COMMITTEE OF THE WHOLE (PUBLIC MEETING) – JANUARY 19, 2021

We appeared before Council last July in response to the two redevelopment proposals for 100 and 180 Steeles Avenue West. This submission is about Chestnut Hill's proposal for 7080 Yonge Street, with two high-rise residential towers, one 20 storeys and the other 40 storeys on top of a 2-storey podium. However, there are many similarities.

7080 Yonge Limited SFRA Deputation

Figure 4 – 45-degree angular plane projection (supplied by the Agent) and SFRA projection (red dashed line)

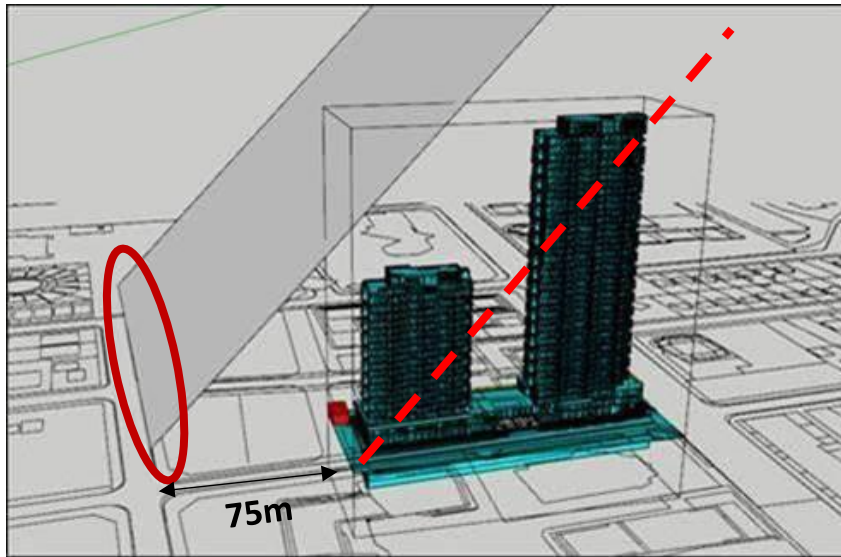
The architectural drawings do not illustrate the 45-degree angular plane from the rear property line required in the City’s Design Review Guidelines (see Figure 3) to transition to the residential neighbourhood to the west.

However, an illustration subsequently provided directly to SFRA by the agent (see Figure 8 below) indicates that the 45-degree angular plane starts at the eastern side of the southern extension of Powell Road, 75 metres to the west (red oval). The problem with that is that there are four properties between Powell and the western boundary of the site, and they have not been purchased by Chestnut Hill to be added to the site, thus in reality the 45-degree angle would start at the western boundary of the site, (our dashed parallel red line) which would intersect the first building at 1 storey and the second at about 18 storeys. Moreover, if the developer followed the Secondary Plan for publicly accessible green space (10m), [see next section], the property line would be 10 metres further to the east, which would further reduce the height intersect of the second building.

Figure 5 – Yonge Steeles Corridor Secondary Plan Schedule 4 (Parks and Publicly Accessible Open Space)

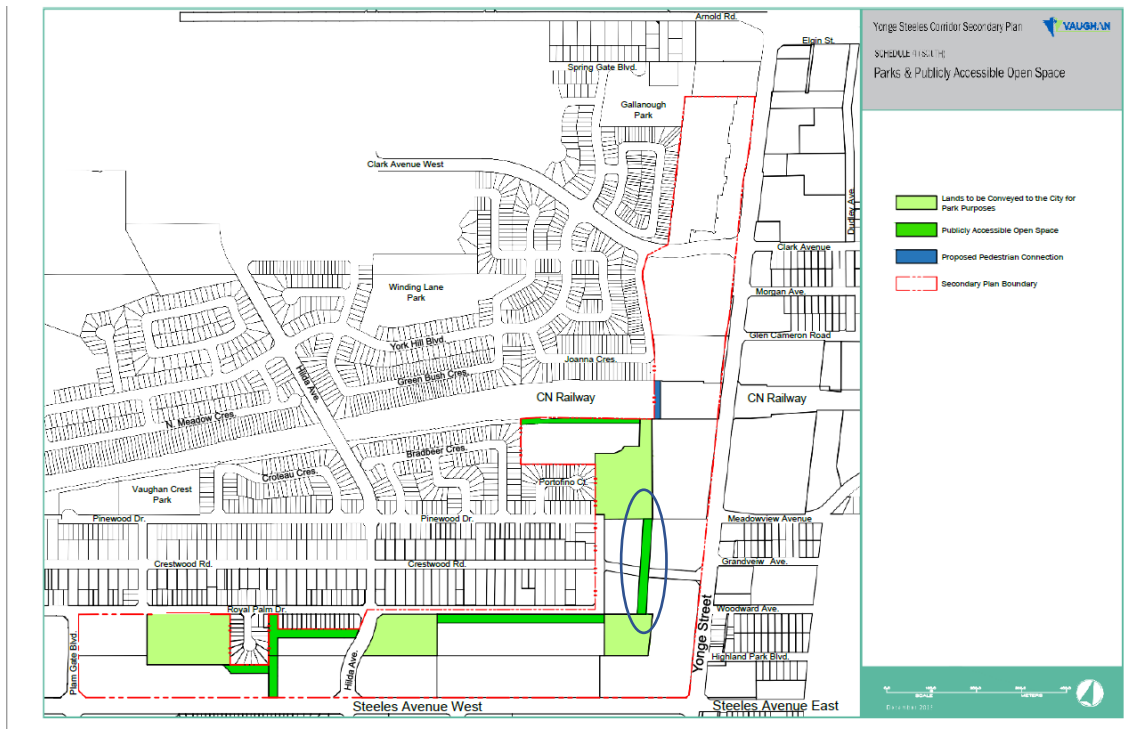
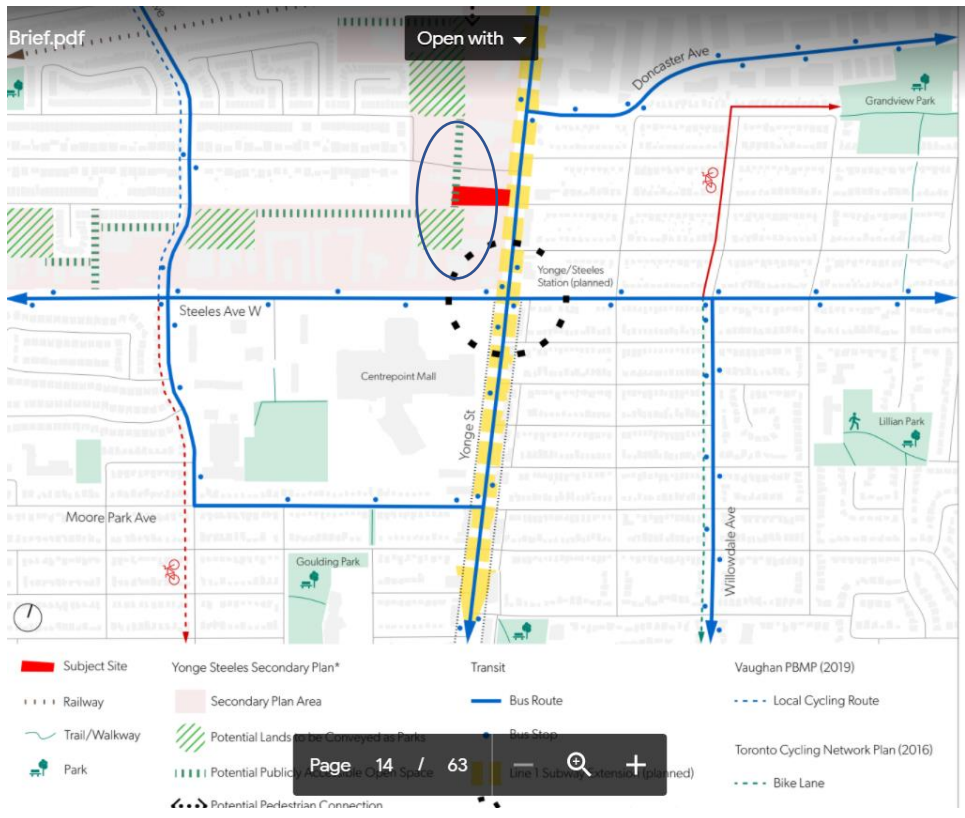
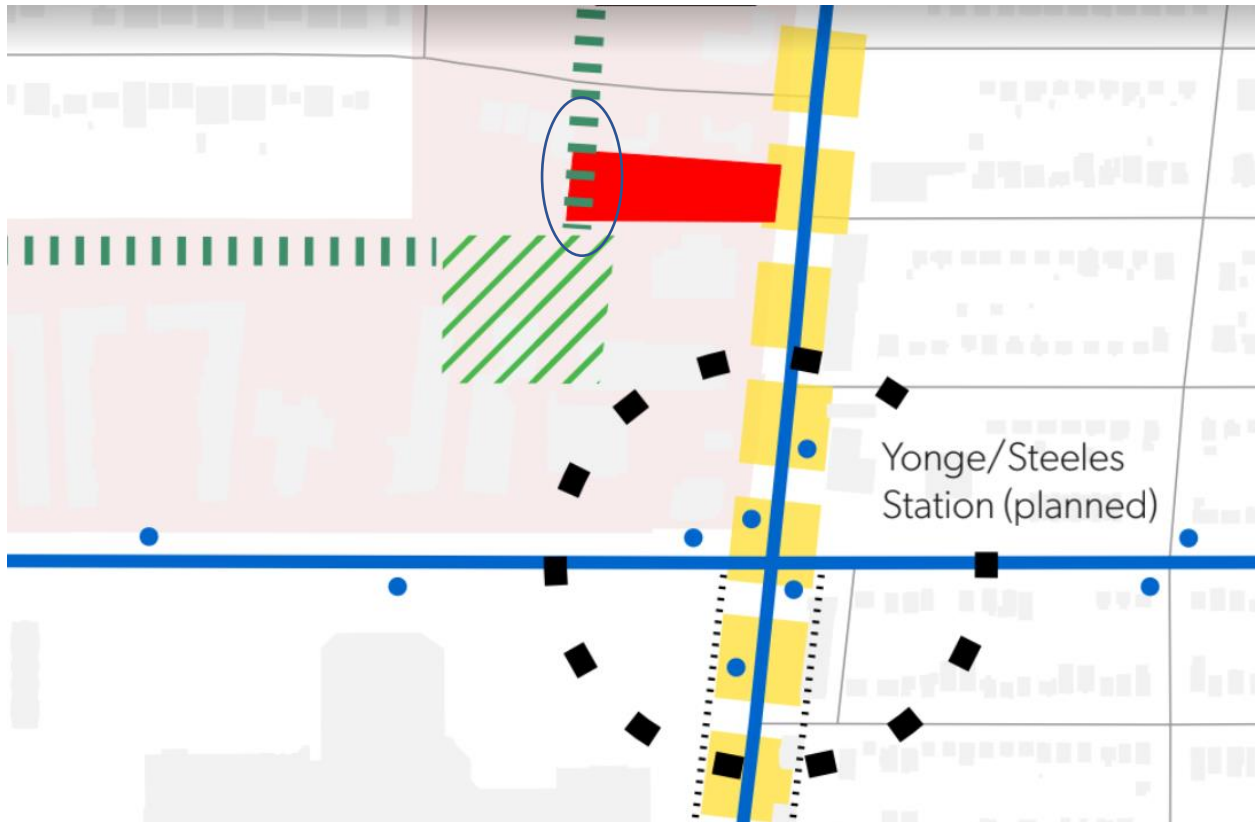
The transition is nonexistent; it is abrupt. **In fact, it actually builds over a 10m wide segment of land designated in the Secondary Plan for a “publicly accessible open space” linear park.** (see Figures 5, 6 and 7 below, inside the blue oval) The Planning Justification Report is silent on this major detail, and does not draw attention to it, let alone attempt to justify it. The intrusion to the green space park only shows up in Figure 5 of the Urban Design Brief, but again there is no textual reference to it there either. There is no green buffer between the houses to the west and the proposed 20-storey building, and most of the green space is private green roof on the podium for the exclusive use of the buildings’ residents.

Figure 12 – Shadow Study (Urban Design Brief, p. 59)

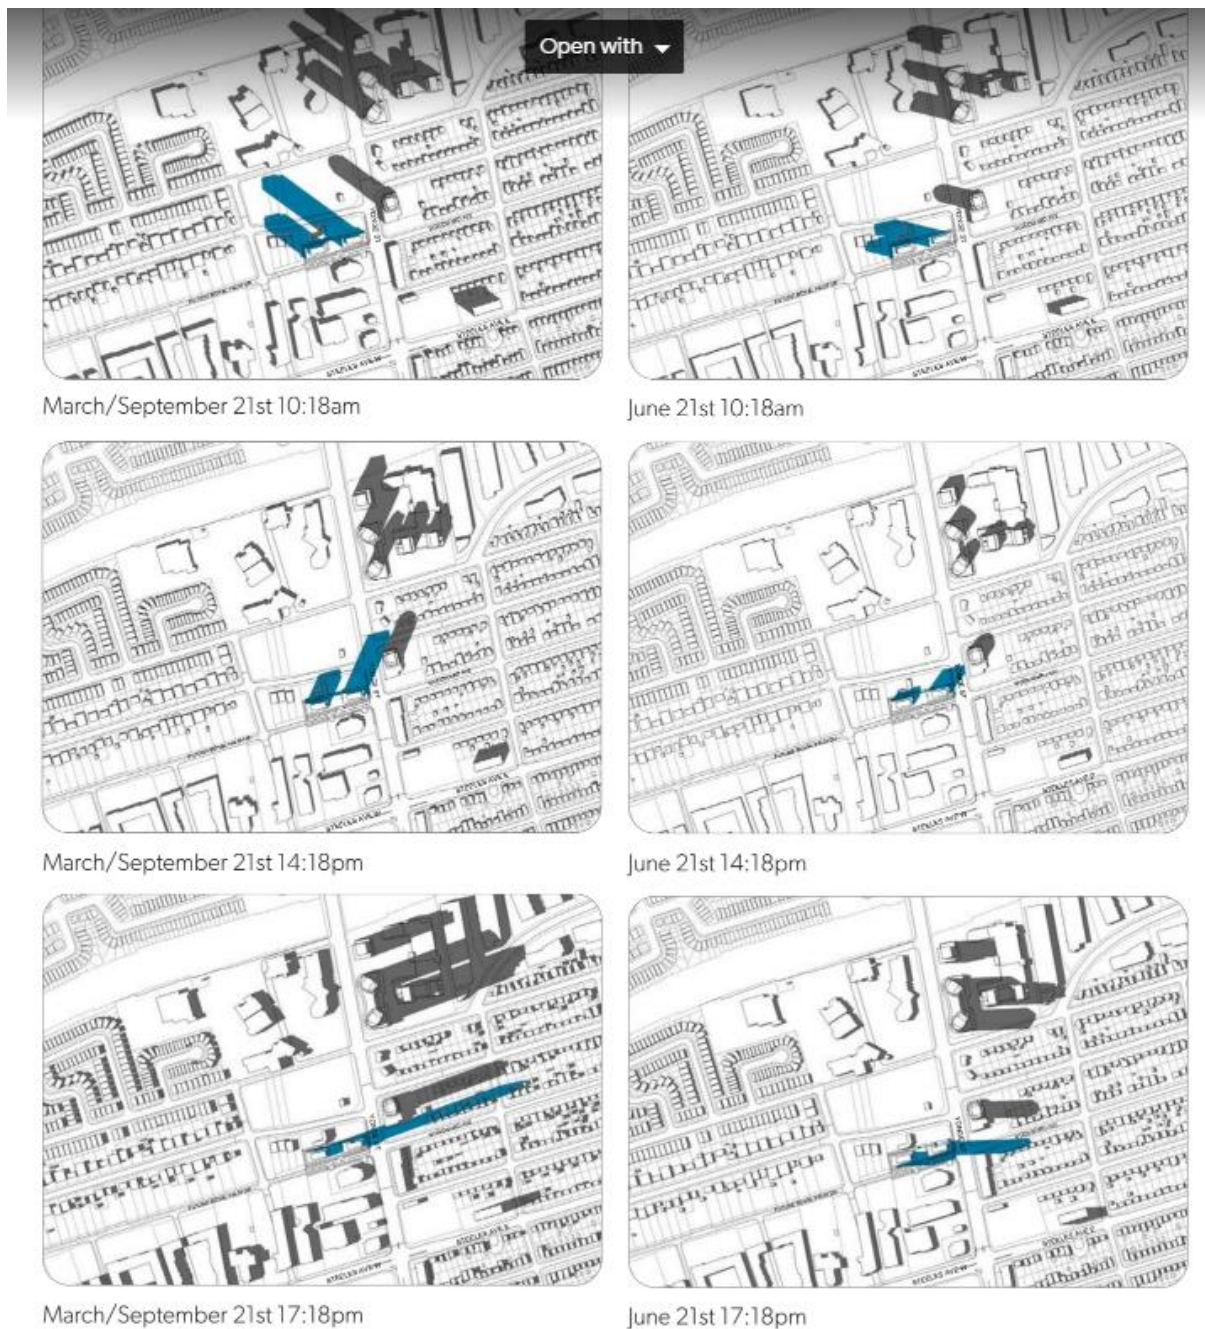
Shadows accrue from building height, massing and siting. The shadow study included in the Urban Design Brief (p. 59) shows strong east-facing shadows onto the Markham side of Yonge Street for March and September at 5: 18pm (see Figure 12)
